# SERVICE LETTER SL55 65-17110

1. **Release Date:** 05/07/2022
2. **Service Letter No.:** SL55-65-17110
3. **Subject:** Bulkhead Reinforcement for Existing Floats
4. **Part/Assembly No.:** 65-17110 (6650) 65-21110 (6750)
5. **Float Models Affected:** 6650 and 6750
6. **Compliance:**  **Mandatory**  **Recommended**  **Optional**
7. **Approval:** All information provided is in accordance with approved data.
8. **Corrective Action:** Non-required.
9. **Estimated Time Required:** 3.5 hours
- 10 **Payments:**  Credit to Customer  Under Warranty  Customer Pays

65-17113 SHOWN  
65-17111 SIMILAR

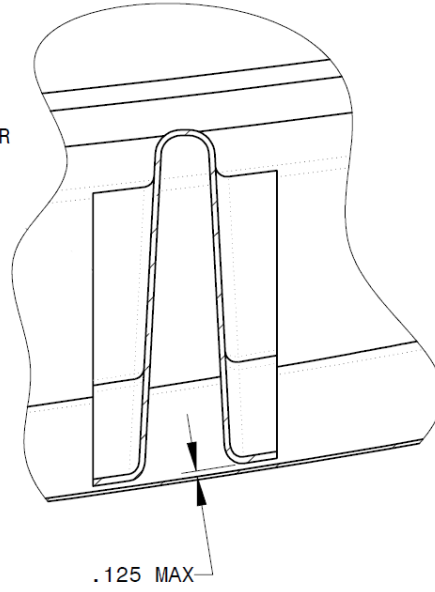
Aerocet has introduced optional reinforcements which may be installed as shown in the diagram below and may be applied without the removal of any bonded float components.

Configuration 65-17110-2 (6650) and 65-21110-2 (6750) both use 65-17111 and 65-17113 Cross-Float Reinforcements, which can be installed in any float constructed before Revision G of 65-17110 Bulkhead Installation. It is intended for retrofit installation.
